**CITY OF BLOOMINGTON
PLAN COMMISSION AGENDA
April 8, 2013 @ 5:30 p.m.**

**BLOOMINGTON PLAN COMMISSION
STAFF REPORT**
Location: 2211 S. High St.

**BLOOMINGTON PLAN COMMISSION
STAFF REPORT
Location: 530 N. College Avenue**

1 SITE IMPROVEMENT PLAN
 1" = 30'

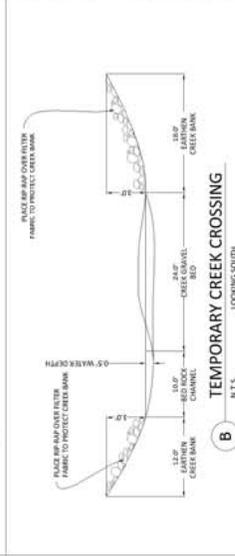
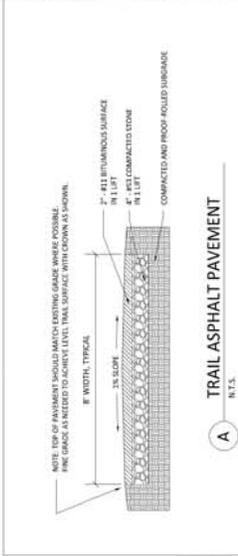
- 1.) If the Petitioner is granted a floodplain variance, they should choose a different material than petroleum asphalt to use as a surface.

- 2.) If the Petitioner is granted a floodplain variance, they should plant a code-compliant riparian buffer to provide the ecological services that they provide.

STAFF RESPONSE: Staff has discussed the possibility of using alternative surfacing materials for the path. The petitioner has indicated that the alternative materials, besides not providing a conducive surface for walking, rollerblading, skating, each have their own set of problems. Paver stones are cost prohibitive and bark mulch or similar material would be washed away in any high water events and do not provide a solid surface.

STAFF RESPONSE: Staff supports this request and will work with the petitioner to come up with a planting plan for the riparian areas consisting of native, wetland plants.

SP/UV-16-13
site plan and first floor plan

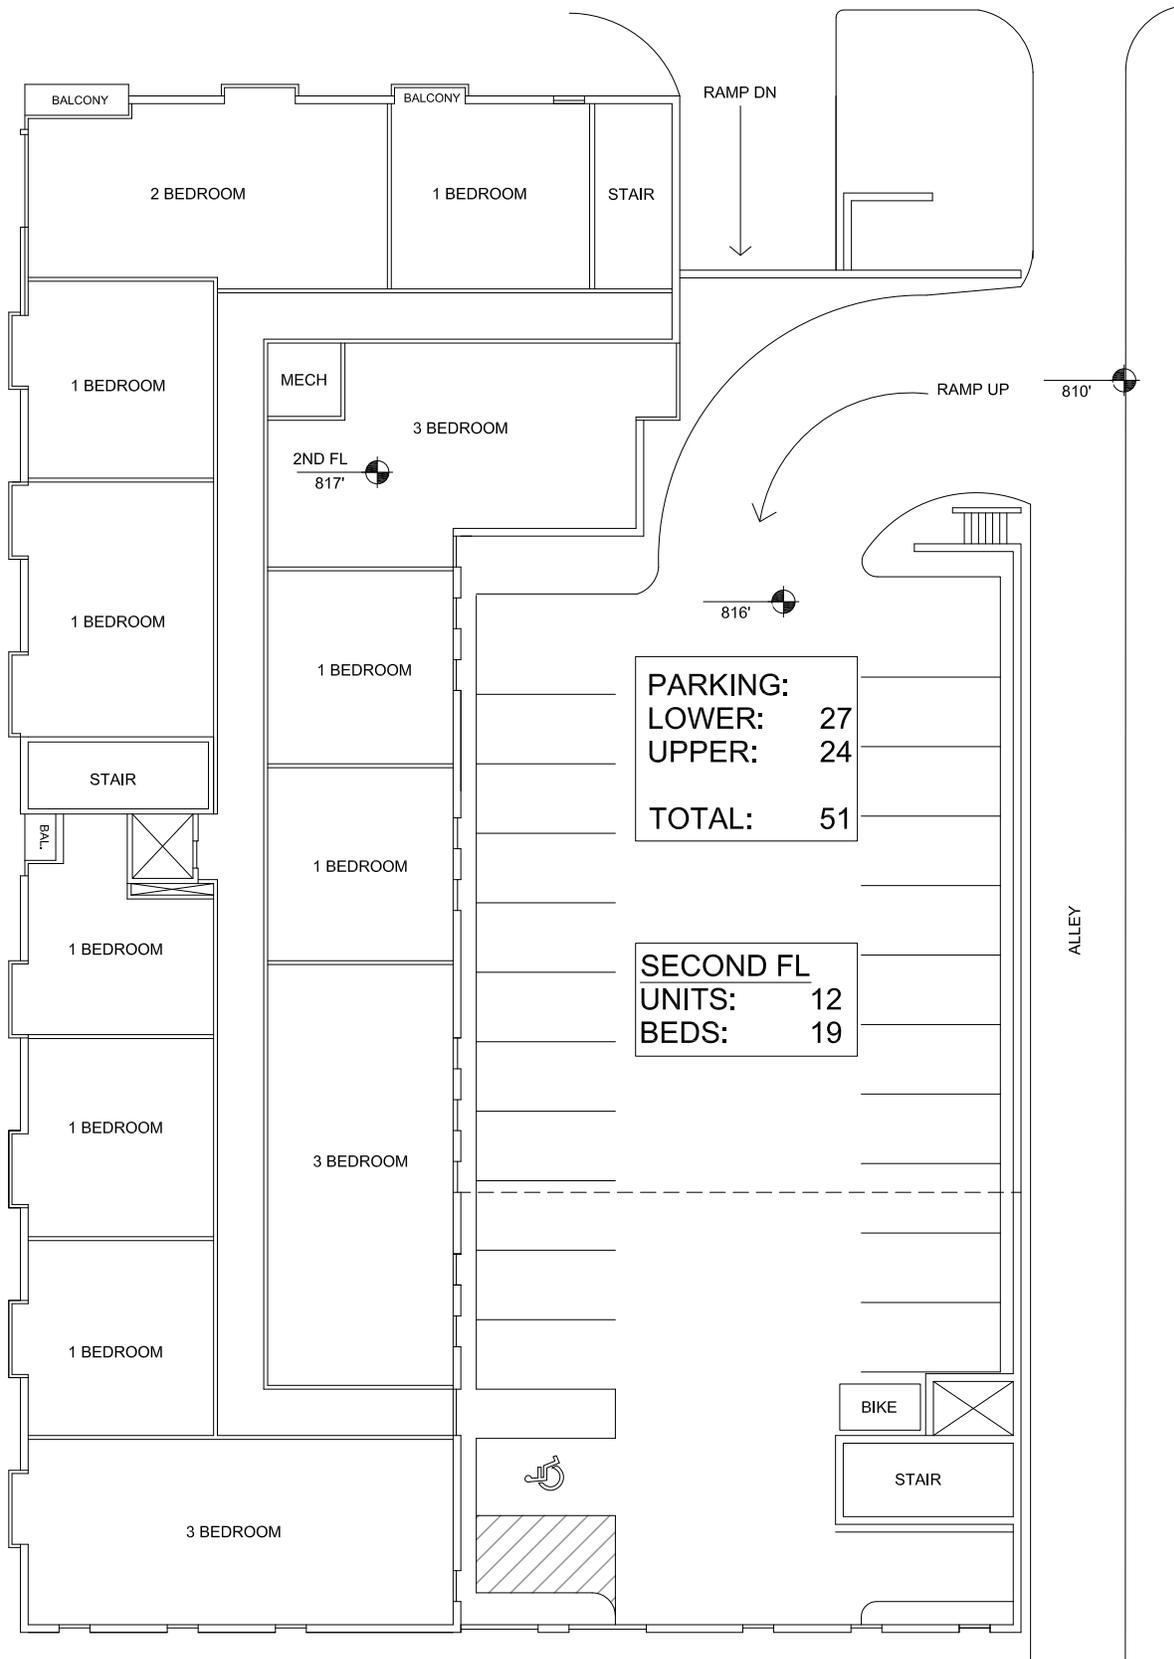
The DCO also requires that all primary façades incorporate a pedestrian entrance. No pedestrian entry is shown on the 10th St. façade. An entry may be feasible into the bank tenant space at the northwest corner of the building. Due to the increasing grade of 10th St. from west to east, this space is higher than the front elevation of the building. An entry on 10th St. may require an interior step or landing to navigate the grade.

Pedestrian Entrances Waiver-20.04.130(a)(6)(A): Staff recommends denial of this waiver from the requirement to provide a pedestrian entrance on 10th St. Staff believes that a pedestrian entry can be added to the northwest corner of the building along 10th St. This entry may require the construction of an interior step or landing.

1. The pedestrian entry waiver for the 10th St. frontage is denied. A pedestrian entry shall be added to the 10th St. façade.
2. The petitioner must meet all primary pedestrian entry detail requirements prior to building permit issuance.
